HISTORIC PRESERVATION COMMISSION

MEMORANDUM

SUBJECT: Historic Area Work Permit #1129183– Construction of new addition and retroactive tree removal

The Montgomery County Historic Preservation Commission (HPC) has reviewed the attached applications for a Historic Area Work Permit (HAWP). This application was **approved with four (4) conditions** at the October 8, 2025 HPC meeting:

1
A302
FRONT DECK SECTION
SCALE: 1 1/2" = 1'-0"

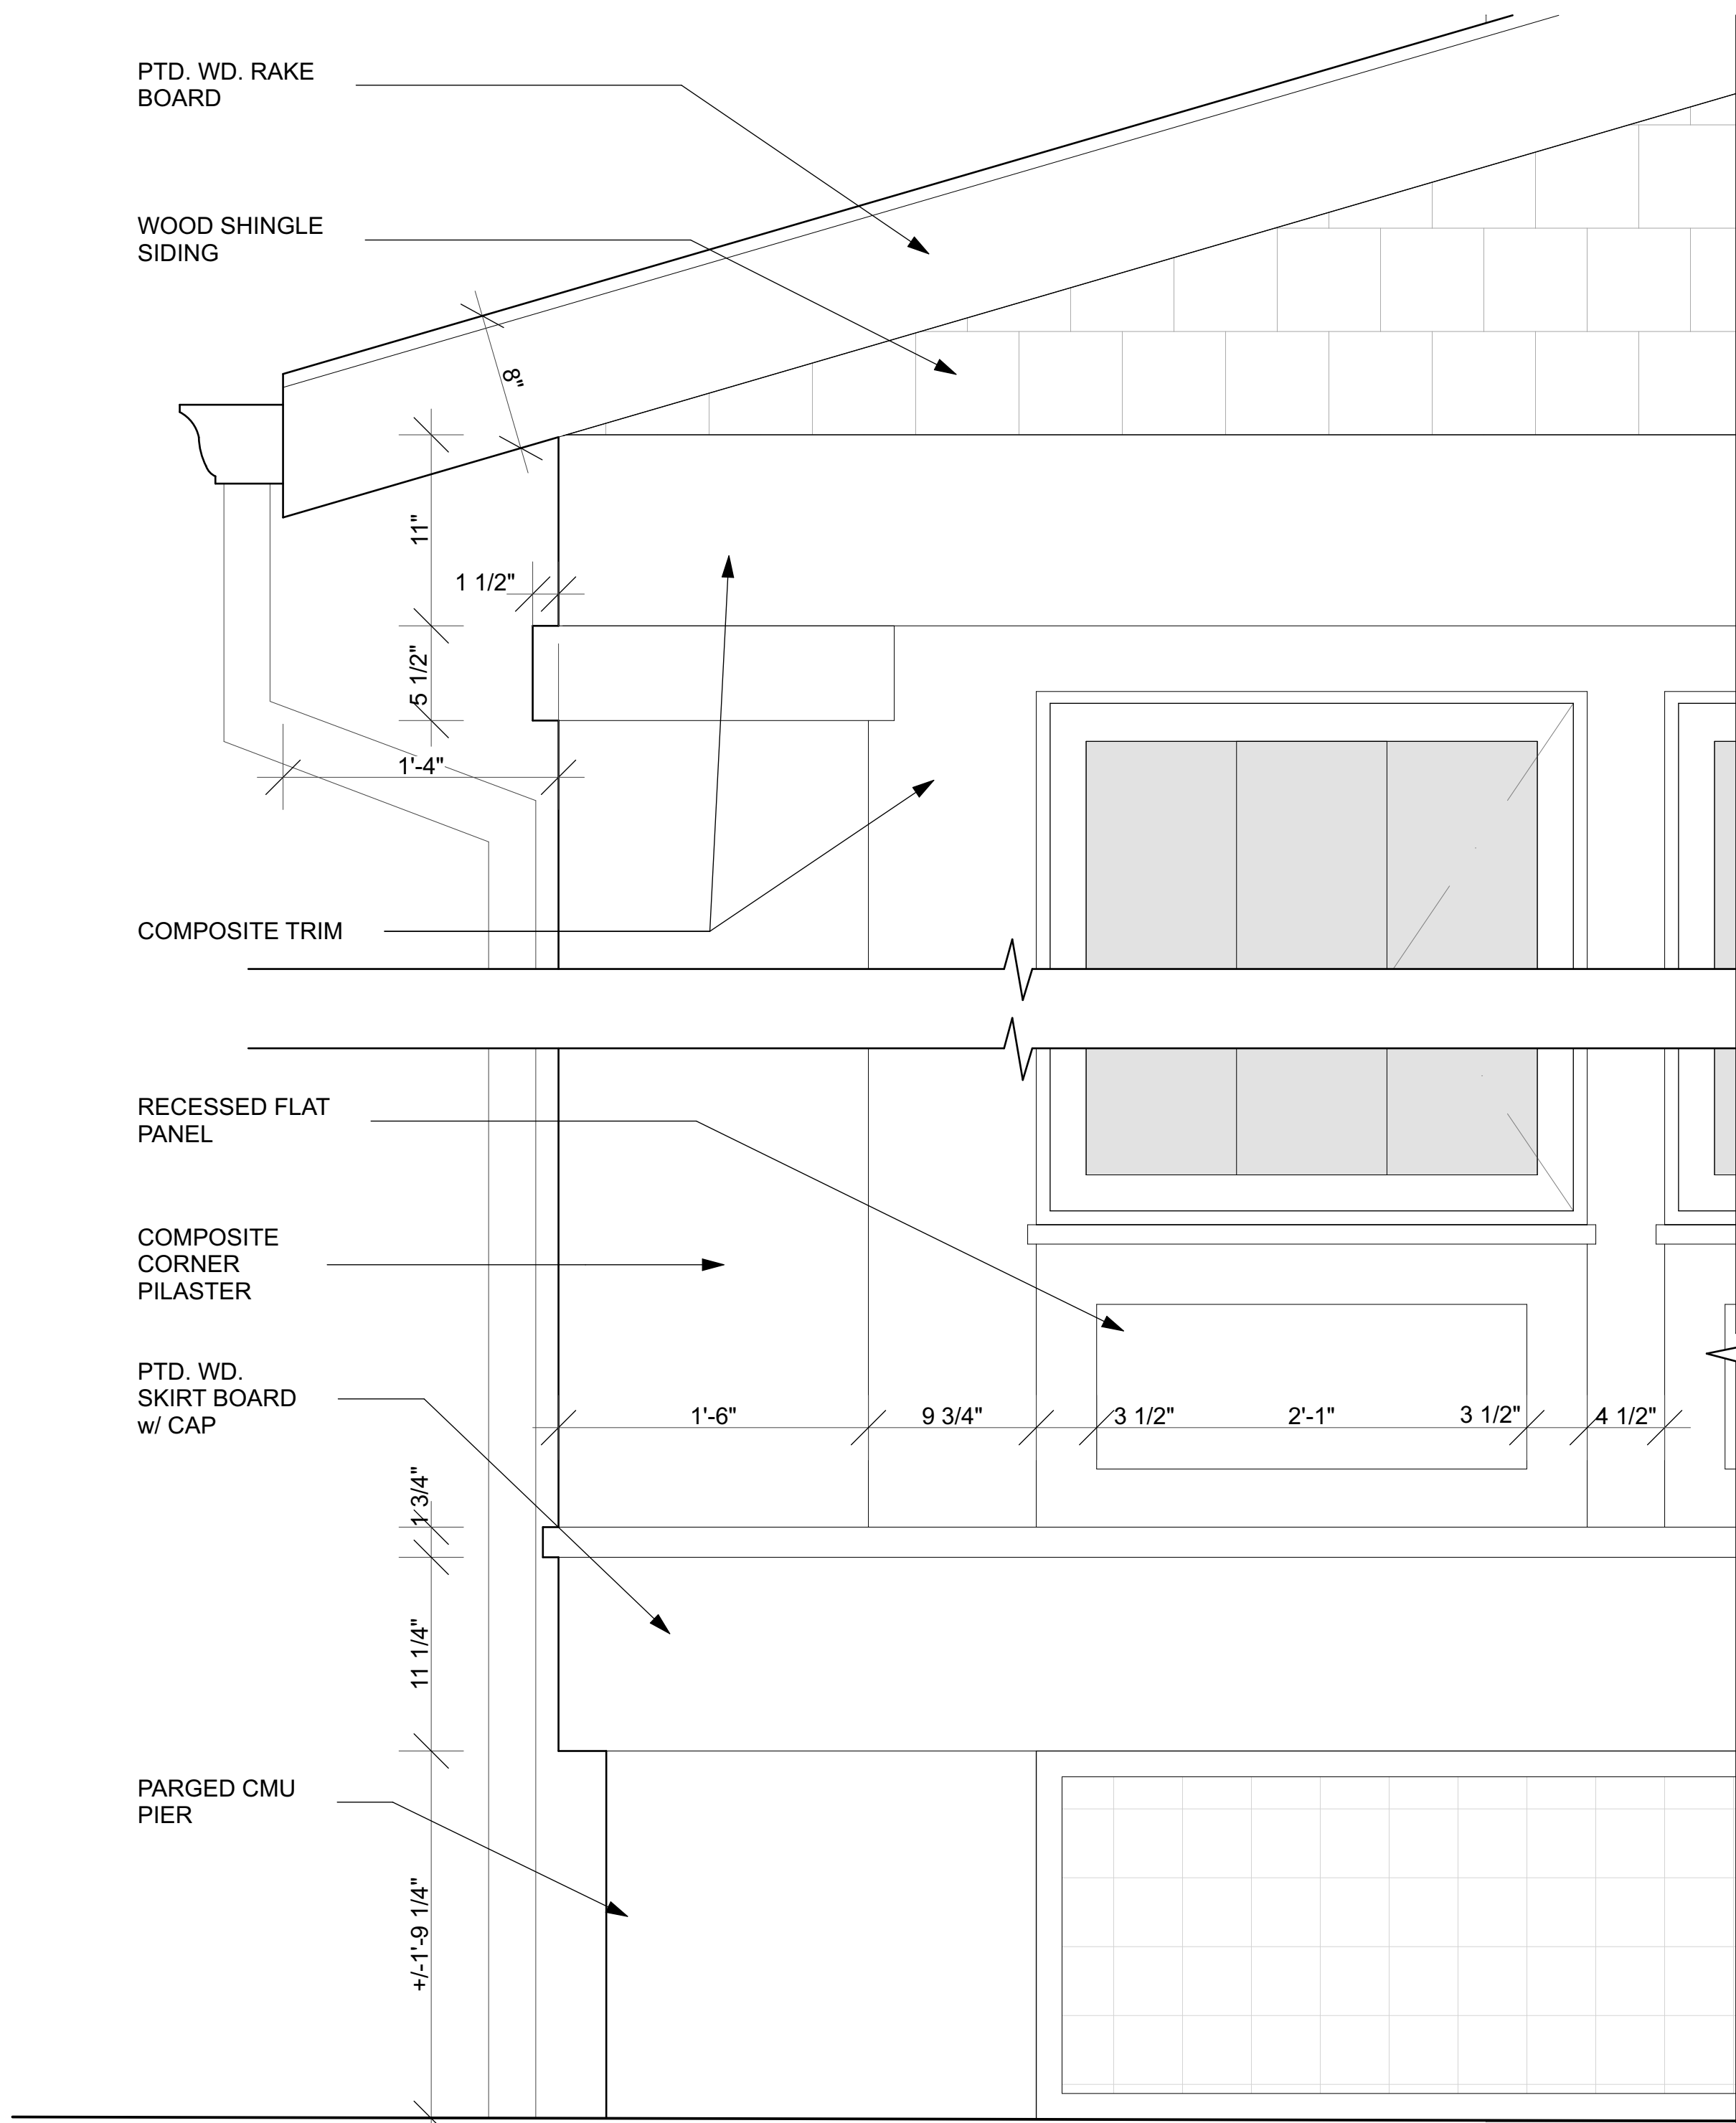
1. The composite decking and stair treads must have solid edge boards.
2. The eave overhang of the proposed addition must be reduced to a maximum of 16 inches.
3. The applicants must plant one large species shade tree on the property.
4. The applicants must submit a complete tree survey by a certified arborist or the Takoma Park arborist identifying the locations, dimensions and species of all trees greater than 6 inches d.b.h on the subject property and confirmation that the proposal will not negatively impact any mature trees.
